Addendum No. 7
Mt. Rose Water Treatment Plant
PWP Bid No.: WA-2018-240
TMWA Capital Project No.: 11-0010
Monday, August 27, 2018

MT. ROSE WATER TREATMENT PLANT
DOOR, HATCH, WINDOW, LOUVER & HARDWARE SCHEDULES & DETAILS

SHEET NUMBER
GA03
78 OF 295

FRAME TYPES

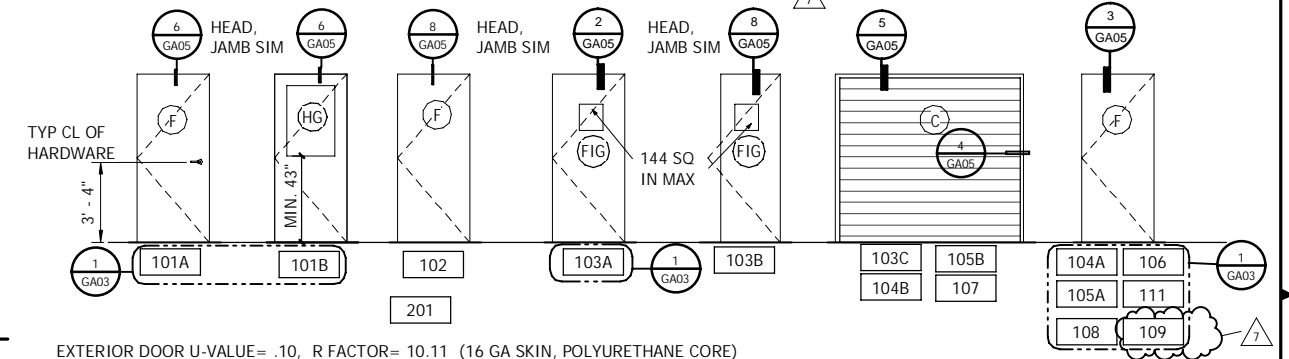
Clarification No. 1:

Sheet GA03: See Revised Sheet GA03 attached that clarifies hardware items.

1. Door 108 receives hardware group 5.
2. Review all the doors for revised hardware group 5 that includes the Von Duprin Panic device 99EO with latching trim.
3. Door 109 uses MODIFIED Hardware group 6: Includes vertical rod panic bars and (1 side) electrified kit panic device for card reader control. REX in non-electrified side panic device. Also added a coordinator, astragal, and power transfer hinge.
4. Modified Detail 1/GA03 for Card Reader Control to include double door 109 per (3) above.
5. NEW Hardware group 7 (Passage Set) applies to Doors 103C, 104B, 105B, 107.
6. See Electrical Division 16 for Card Reader specifications.
7. See Electrical Drawings (Addendum 7) for added conduit and data for electric strikes and card reader locations as called for in the GA03 Door and Hardware Schedule.
8. Added a Type C Hollow Metal frame for Door 109.

Drawing No. GA03: Delete GA03 and replace with attached GA03.
